# Access Compliance Report

### (Curb Ramps)

| Intersection ID: 53253                  | Main Street: MARLOWE_AV | Cross Street: ALYSSA_LN                 | Location: NE           |
| ADA ID: 680F63FF22F2                    | Ramp Type: Perp         | Initial Pass/Fail: Fail                 | Overall Compliance: No |

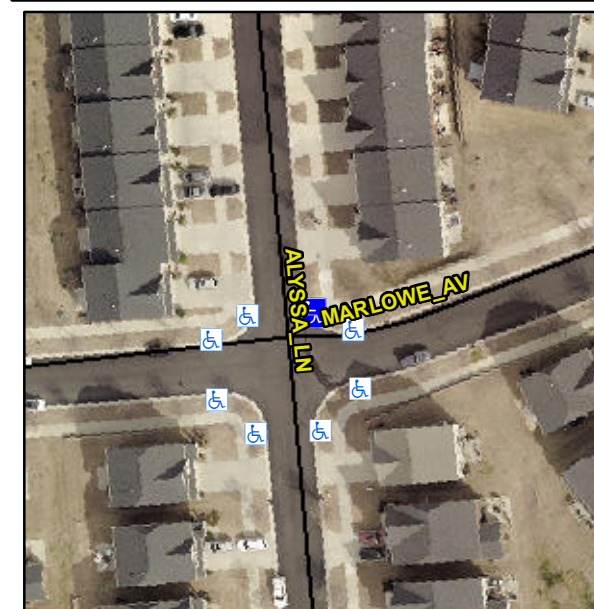
**Not Found, R304.5.1, R304.2.2, R304.5.3**

| Compliance | Description           | Data | Compliance | Description                 | Data |
|------------|-----------------------|------|------------|-----------------------------|------|
| N/A        | Ramp Length (in)      | 96.5 | No         | Ramp Slope (%)              | 10.5 |
| No         | Ramp Width (in)       | 47.0 | No         | Ramp XSlope (%)             | 11.4 |

**Remove & Replace Entire Ramp.**
